## ADDENDUM No. 3

### RFP No. 26-11

#### N. University and Thayer Improvements

SCALE PLAN: ###  
DRAWING NO. 2023-025-57

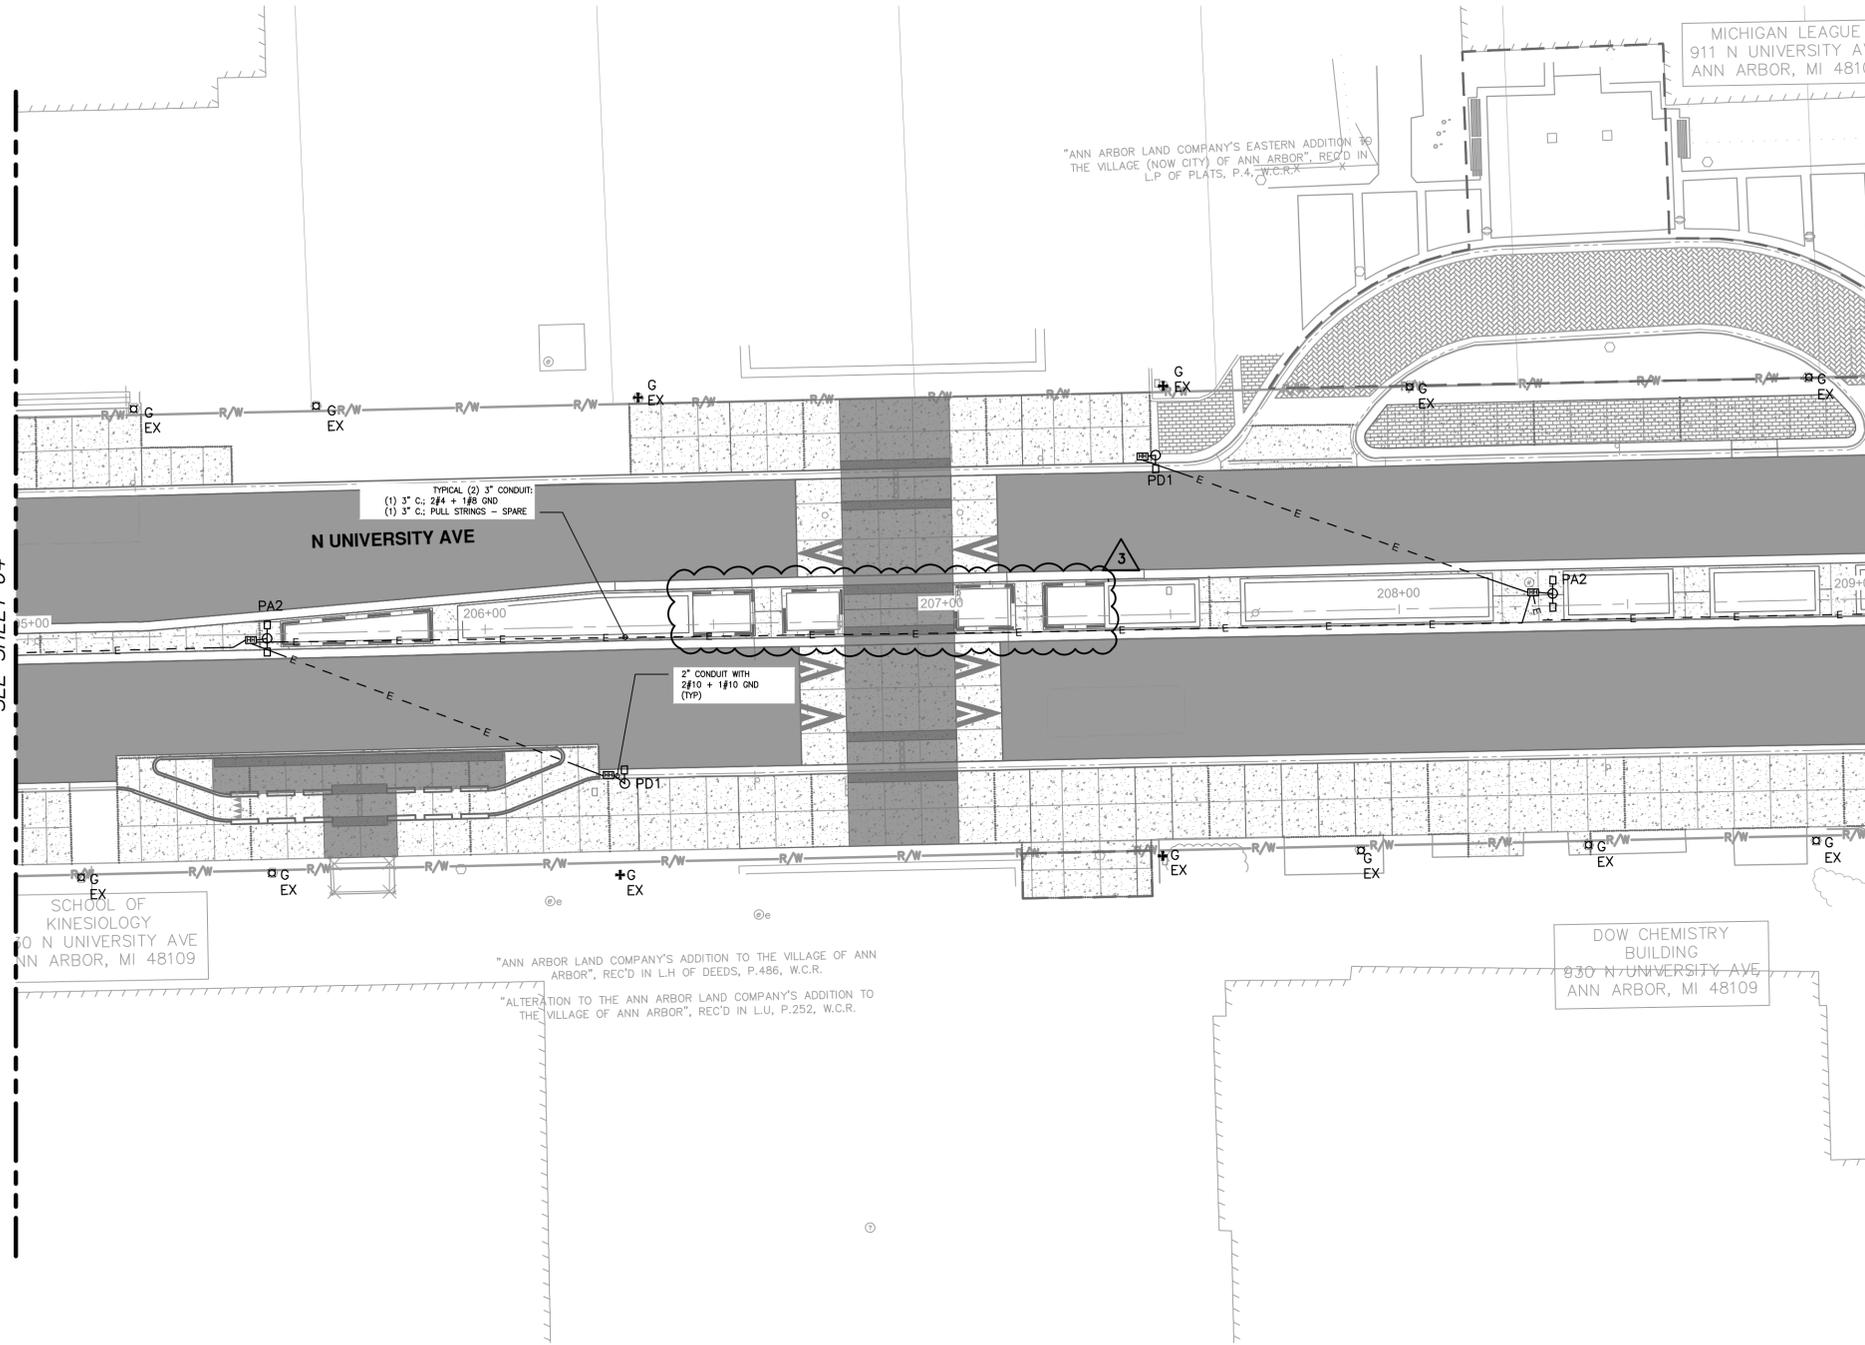
| Plan Sheet 57     | Revision of layout of proposed planter boxes.   |

SCALE: 1"=20'  
DRAWING No.  
2023-023-65

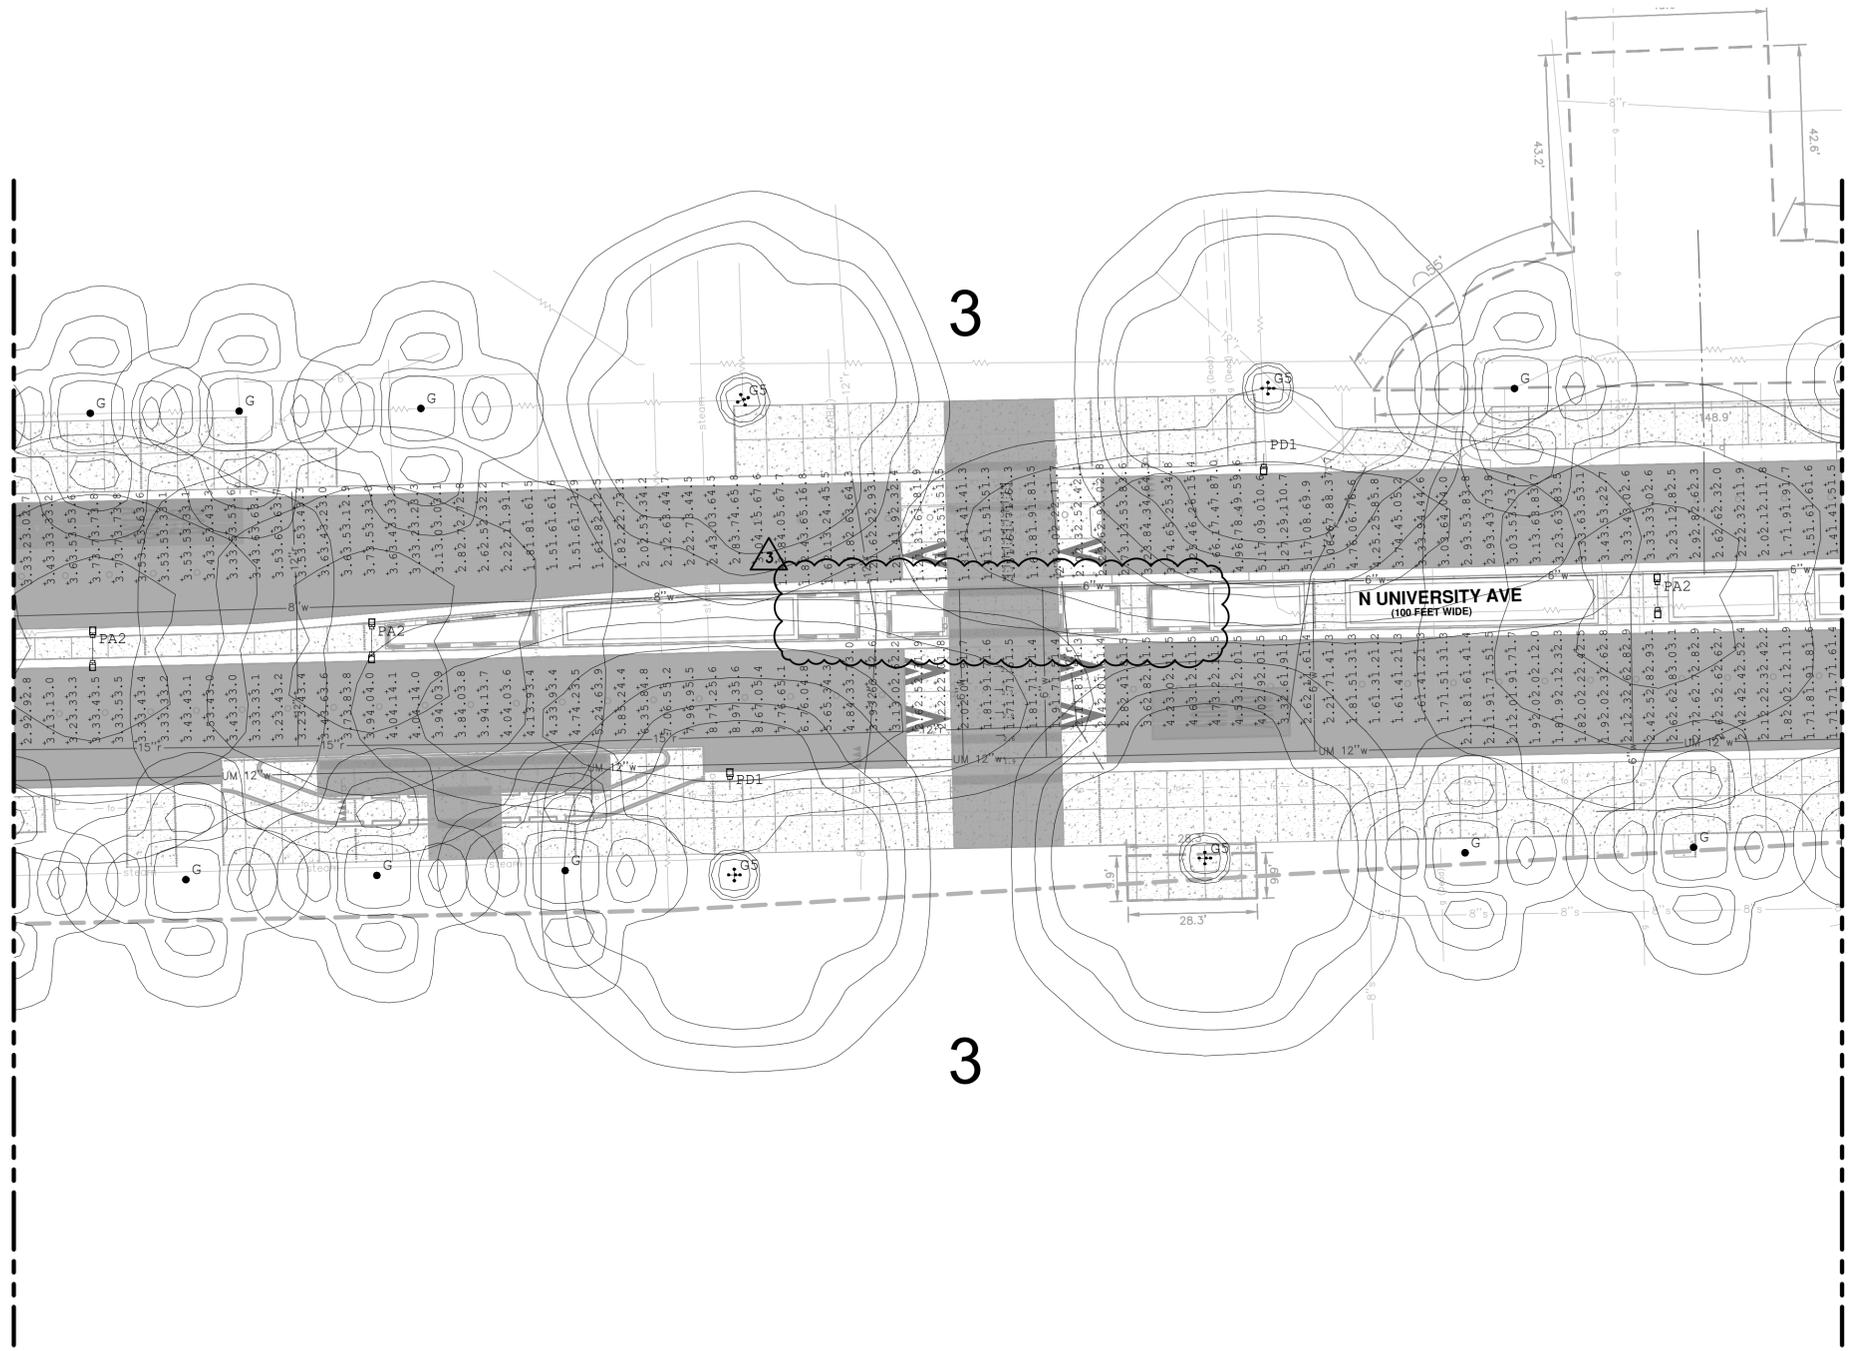
| Plan Sheet 65     | Revision of layout of proposed planter boxes.   |

SHEET No. 81 of 83

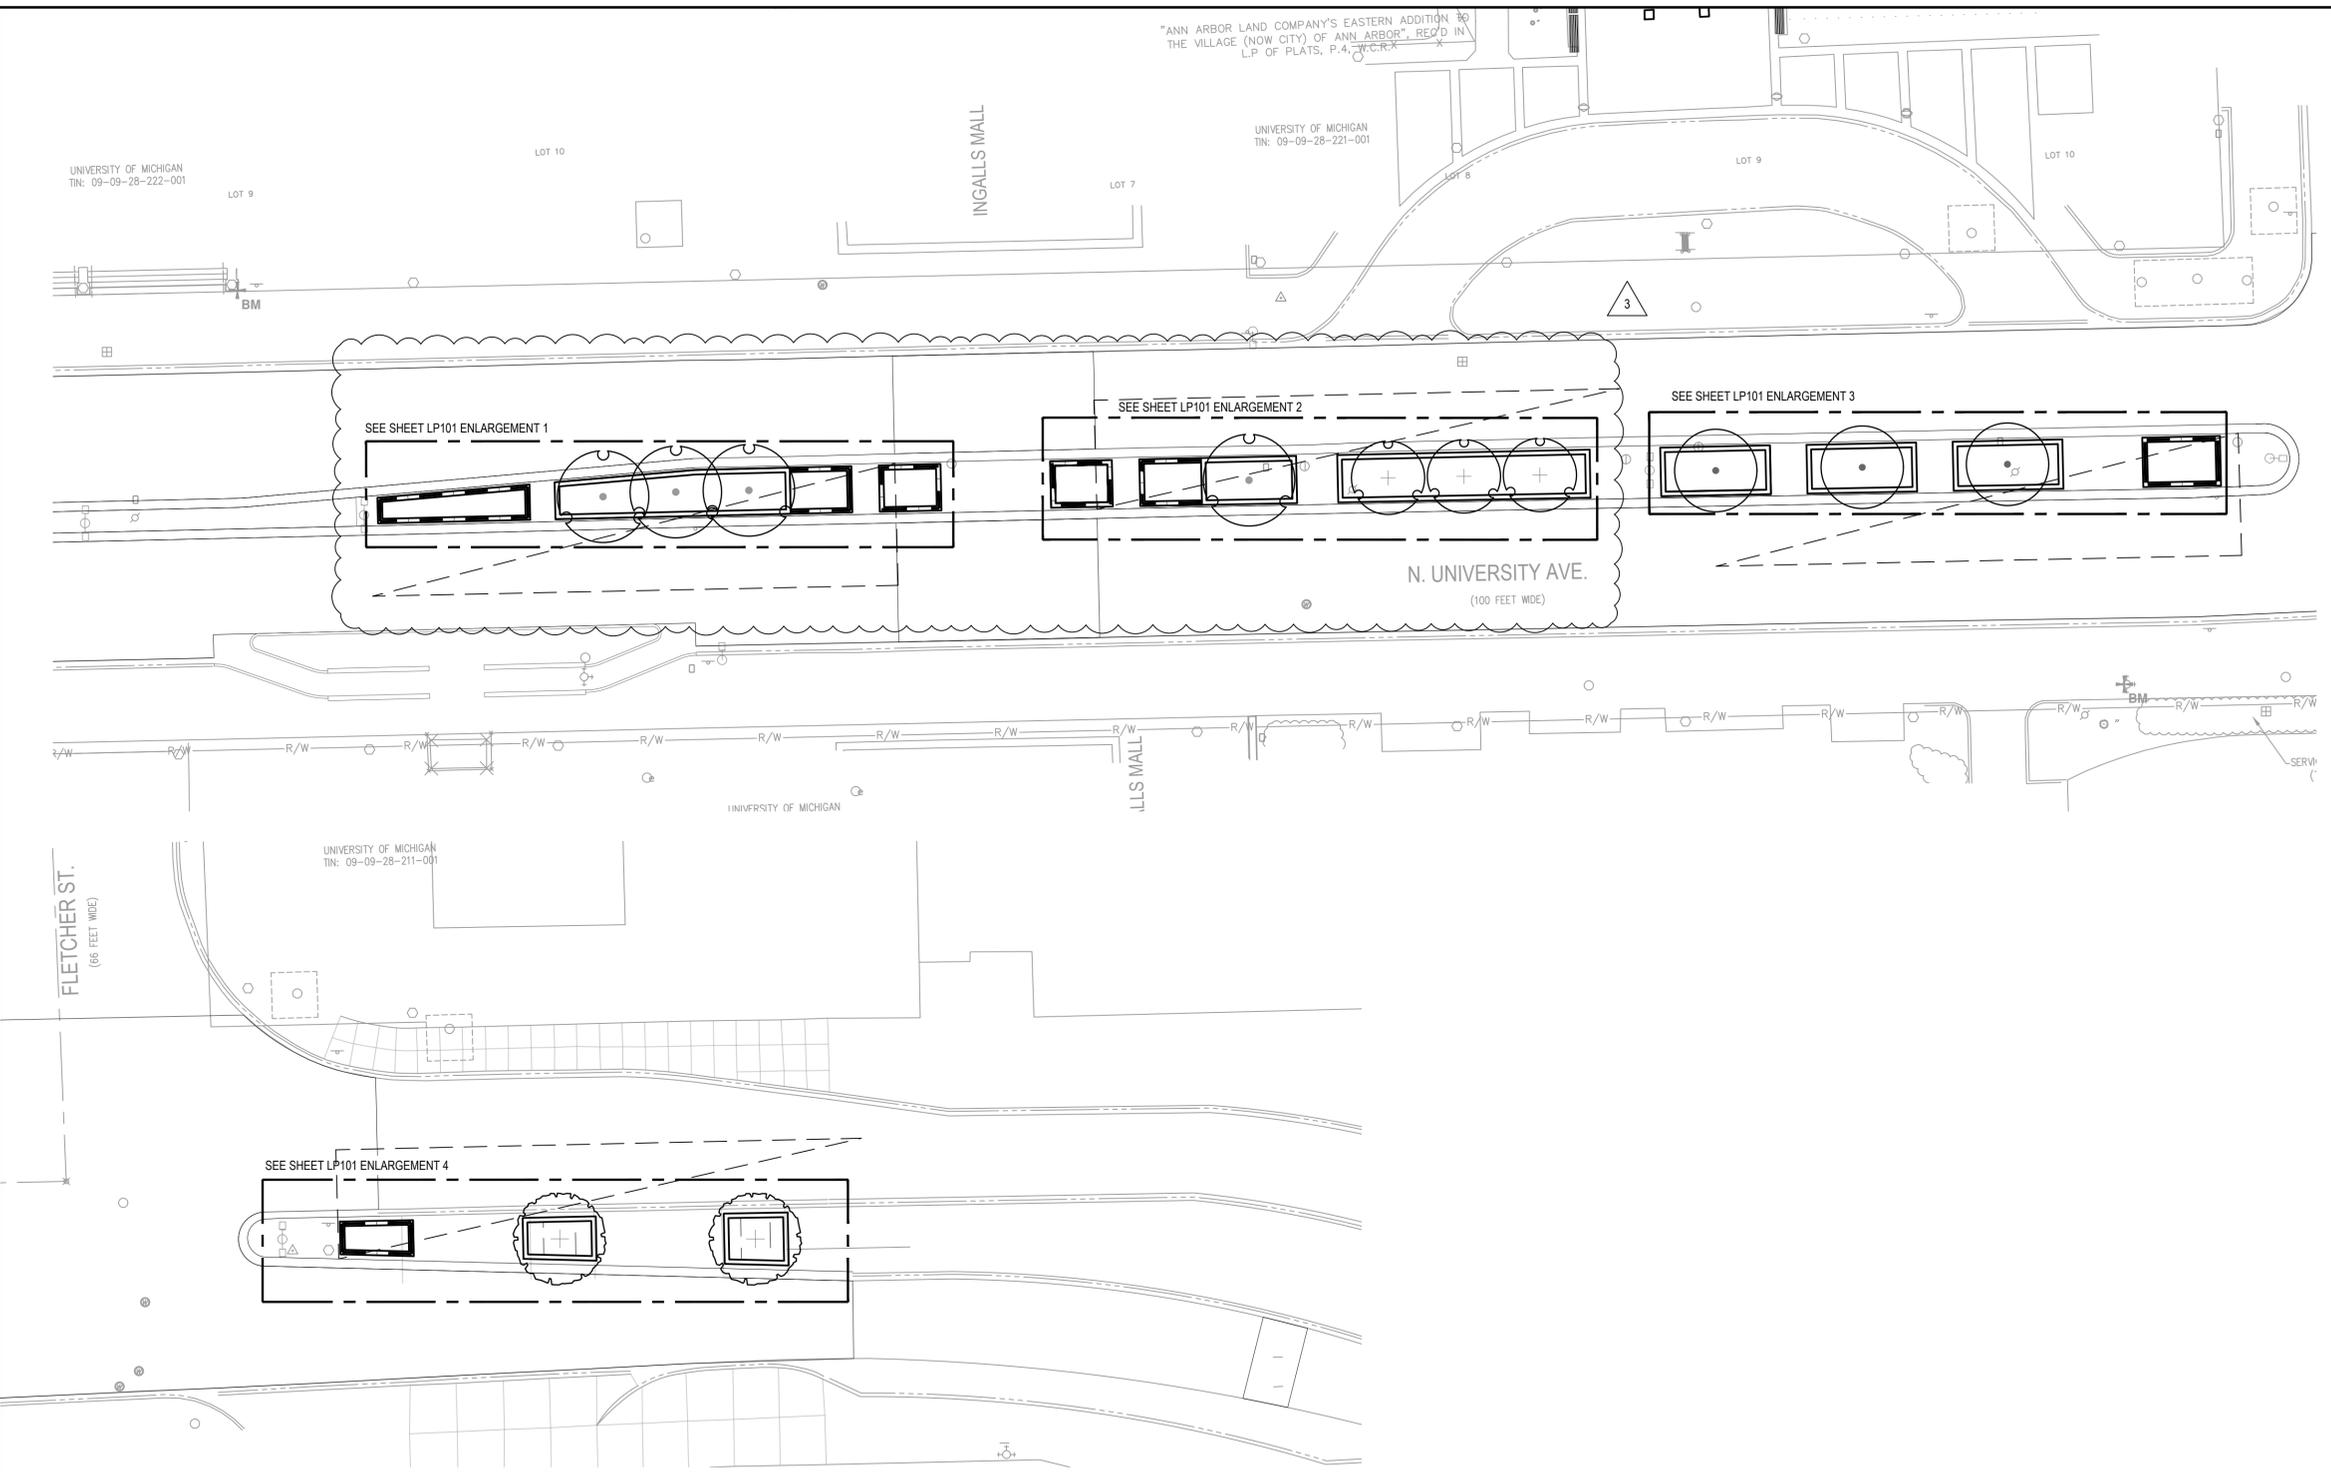
| Plan Sheets 81-83 | Revision of layout and design of planter boxes.   |

1. UPDATED PLANTER WALL EXTENTS AND ASSOCIATED PLANTINGS
